STRUCTURES DESIGN BULLETIN C11-07 **ROADWAY DESIGN BULLETIN 11-07**

DATE: June 30, 2011

SUBJECT: Incorporation of Prefabricated Steel Truss Pedestrian Bridges in FDOT Bid Documents

Figure 8.2 Prefabricated Pedestrian Bridge Standard Truss Configurations

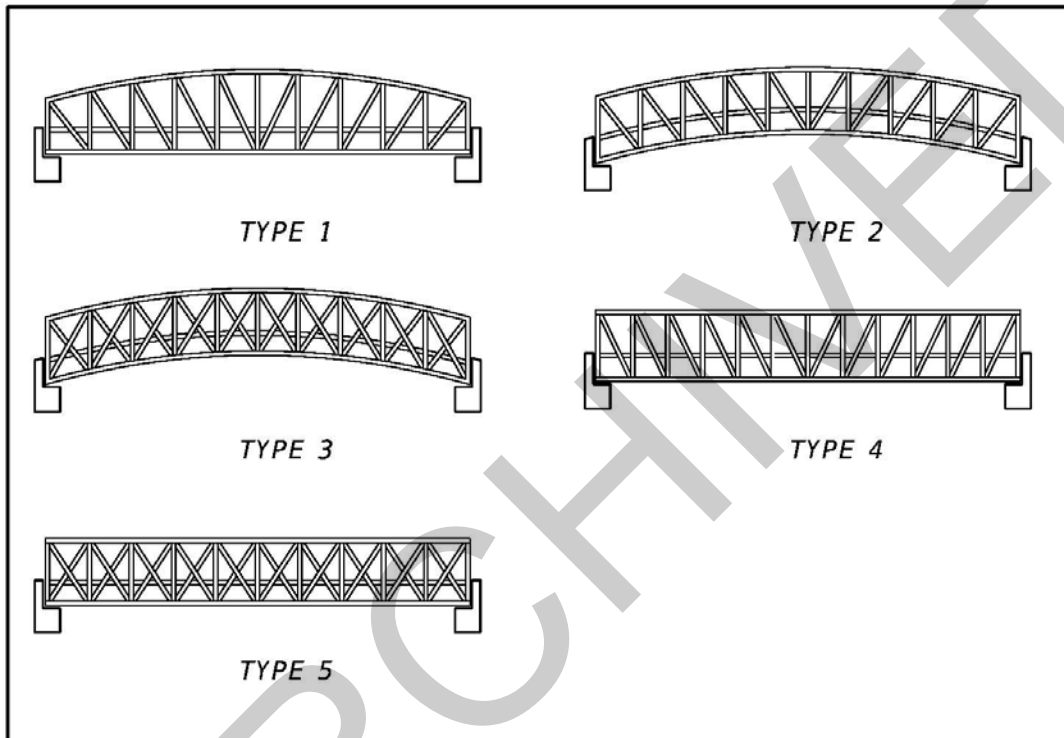
1. Using Figures 8.2, 8.3, and 8.4, coordinate with the District Project Manager to select all allowable truss configurations, truss member shapes, and bridge cross-sections. Note that for spans greater than 150 feet a box truss bridge cross-section is required.

If project specific aesthetic requirements warrant the use of truss configurations not included in Figure 8.2 the project EOR can specify additional truss configurations. However, a minimum of two steel truss pedestrian bridge producers shall be capable of satisfying the aesthetic requirements.

2. Insert sub-article 8.7.2 below Figure 8.1 as follows:

Figure 8.4 Prefabricated Pedestrian Standard Bridge Cross-Sections

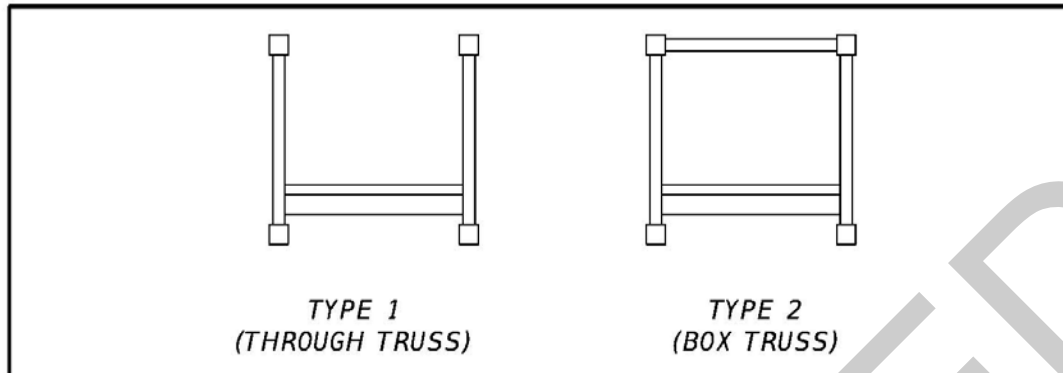
Through Truss is limited to spans lengths less than 150 feet.
